Service Bulletin

BKSB-1003A
Issue Date 08-15-01

UPDATE TO BKSB-1003. ISSUED 8-2000

Issue: Possible GPH communication failure.

Figure 2

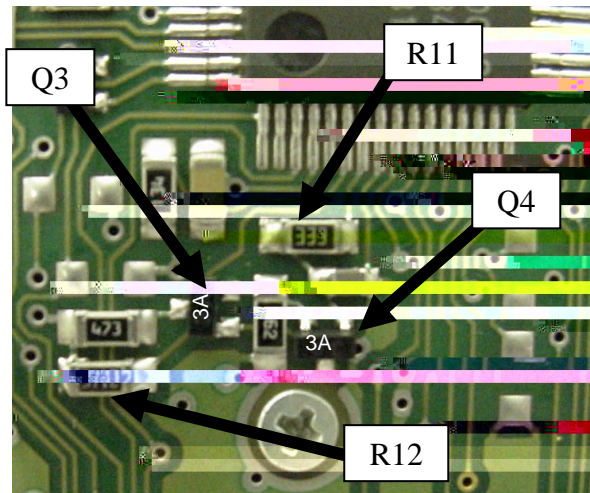
1. Turn off radio and remove battery.
2. Disassemble radio.
 - a) Remove 4 screws from rear cover of radio.
 - b) Pull front radio assembly straight out.
 - c) Gently slide white connector clip up and disconnect flex circuit from options board.
 - d) Remove five screws from options board and disconnect from keyboard. (Fig.2)
3. On the keyboard, check the markings on Q3 and Q4.

Figure 3

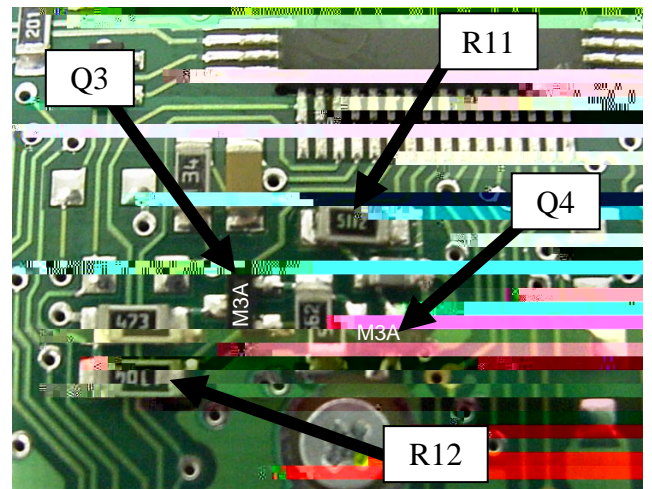
Due to a change in supplier of Q3 and Q4 on GPH Alphanumeric keyboards, R11 and R12 of the keyboard must be specific values to match the manufacturer. If R11 and R12 are the incorrect value the GPH may realize a communication failure between the keyboard and the core processor. This condition could result in the GPH "locking up". By cycling power the GPH will resume normal operation.

Should a radio display this condition check the value of R11 and R12 as detailed in Figure 3 and perform the following procedure as required.

If the markings on Q3 and Q4 are 3A

R11 should be marked 333
R12 should be marked 5112

If the markings on Q3 and Q4 are M3A

R11 should be marked 5112
R12 should be marked 104

For Units with Q3 and Q4 marked 3A:

- 1 - Surface Mount 33K Ohm Resistor (PN 4718-50237-398) R11
- 1 - Surface Mount 51.1K Ohm Resistor (PN 4718-50317-198) R12

For Units with Q3 and Q4 marked M3A:

- 1 - Surface Mount 51.1K Ohm Resistor (PN 4718-50317-198) R11
- 1 - Surface Mount 100K Ohm Resistor (PN 4718-50237-322) R12
